MAHNCKE PARK NEIGHBORHOOD CONSERVATION DISTRICT (NCD) 6

Zoning Commission Briefing NCD Update

March 5, 2019

Lot Size/Coverage (Front Setback)

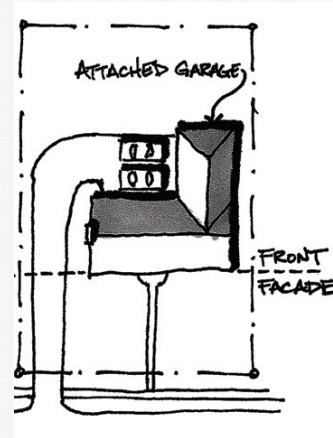
- Taskforce Recommendations:
 - Modifies median front setback from 5 Ft to 8 Ft of median block-face.
 - Proposed revisions that applies the median setback only if a minimum of 5 existing single family residential structures on the block-face.
- Community Input:
 - Define the median setback by blockface, if volunteers can take measurements in time. This becomes the front setback for each blockface.
 - Define primary street.

- Staff recommendations:
 - Staff updated language that keeps the front setback of 5 feet from the median.
 - Staff updated language that removes the applicability of the median setback based on use.
 - Staff updated language that defines primary street as the street in which a property is addressed on.

Garages, Carports, Accessory Structures and Accessory Dwellings

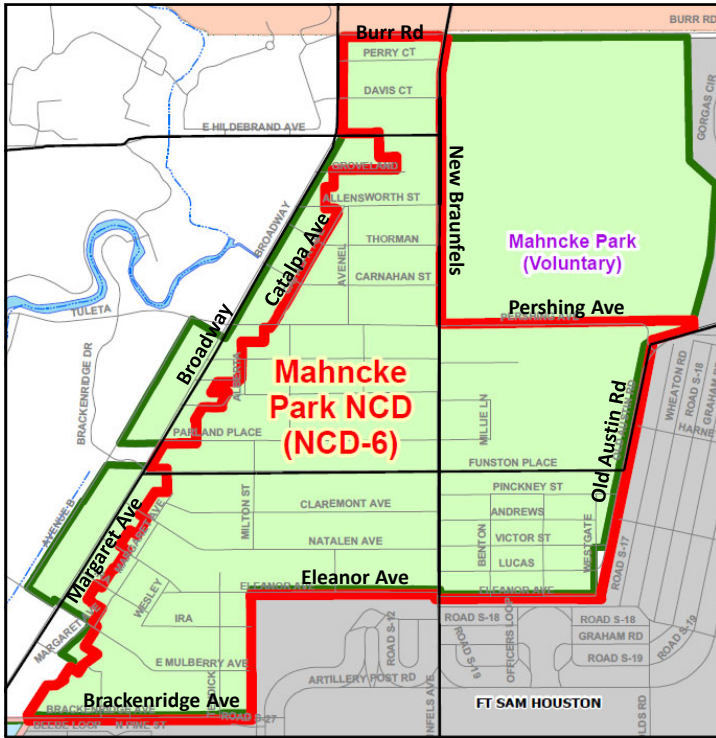
- Taskforce Recommendations:
 - Proposed revisions to placement of garages or carports if facing the same direction as the front façade of the principal dwelling that removes requirement to be detached and behind the principal structure. Proposed language that allows placement behind the principal dwellings forward most architectural feature.
 - Recommended changes to the building materials for vertical supports or structure materials of porte cocheres that now requires a match to the primary structures. No longer allows materials matching primary structure placement and profile.
- Community Input:
 - Allow porte cocheres to be flush with the principal structure's front façade.
 - Clarify language that allows attached garages or carports.

- Staff recommendations:
 - Staff kept language that requires garage or carport to be detached from the principal structure and located behind the principal dwelling if facing the same direction of the front façade. Maintains exemptions for lots less than or equal to 110 feet deep or lots less than 35 feet wide.
 - Staff updated language that clarifies garages or carports not facing the same direction as the front façade may be attached, if located 20 feet behind the front façade.
 - Staff kept language that allows flexibility for use of building materials for vertical supports for replacement or renovations.
